ED-HMI3120-156C

PCN

Product Change Notice 1

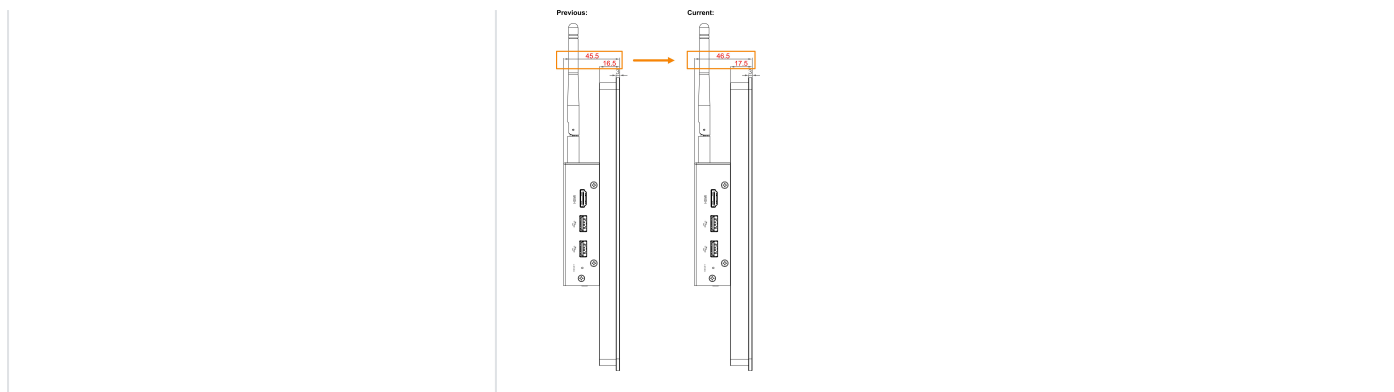
Changes	Results
LCD bezel thickness increased by 1mm	We have optimized the LCD bezel structure to provide additional clearance for internal cable routing. - LCD bezel thickness: adjusted from 16.5mm to 17.5mm. - Total product thickness: correspondingly adjusted from 45.5mm to 46.5mm.
